Access Compliance Report

Public Rights-of-Way

(Curb Ramps)

Intersection ID: 46668	Main Street: PICASSO_CT	Cross Street: CARD_ST	Location: SW
ADA ID: FEE189EF8F02	Ramp Type: BlendTrans2	Initial Pass/Fail: Pass	Overall Compliance: No
Codes/Mitigation Info/Possible Solution		Field Measurements/Component Compliance

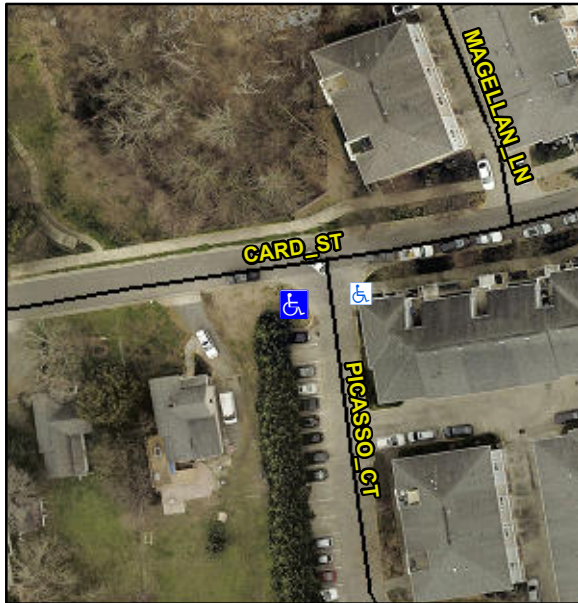
NO CURB

PROW/ADA:

R305, R304.5.3

**Install Detectable Warning System.
Remove & Replace Gutter.**
